**Subject: Jericho Diamond Mine
Processed Kimberlite Containment Area
East and Southeast Dam – Reply to Acres and INAC Comments**

The following addresses technical questions raised in the letter to the Nunavut Water Board from Acres International Limited, dated October 20, 2005 regarding EBA's Jericho East and Southeast Dams Design Report.

TO: File
FROM: Bill Horne
SUBJECT: Stability Analysis of East and South Dams
Jericho Diamond Mine, Nunavut

Stability Analysis - Upstream, Rapid Drawdown - Rotational Slip Surface
Figure A2

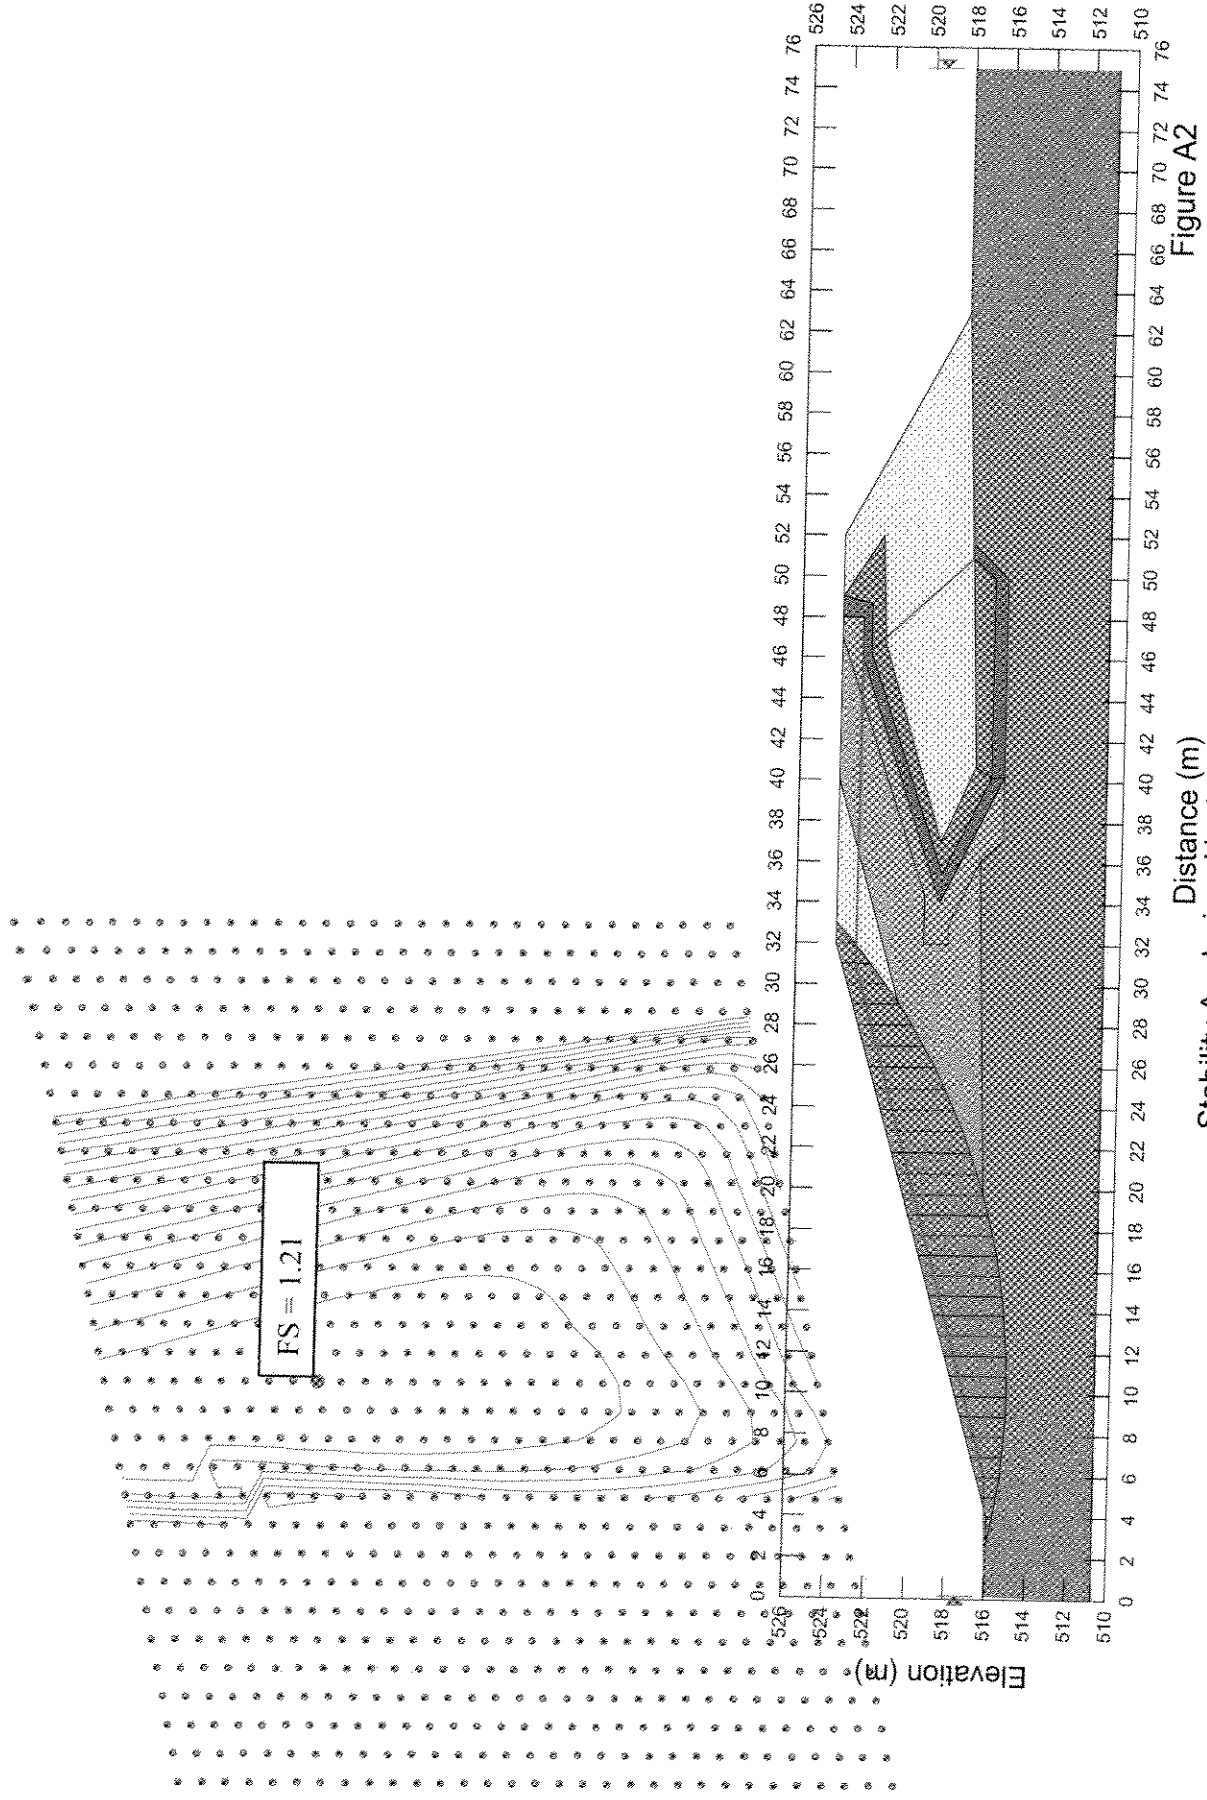
- No excess pore pressures were assumed for the end of construction case. The dam will be constructed during the winter. Thaw consolidation is not expected to result in excess pore pressures due to the relatively slow thaw, and the coarse nature of the till.
- The rapid drawdown case assumed the water level as shown in Figure A.2 of the attached stability analyses memo.
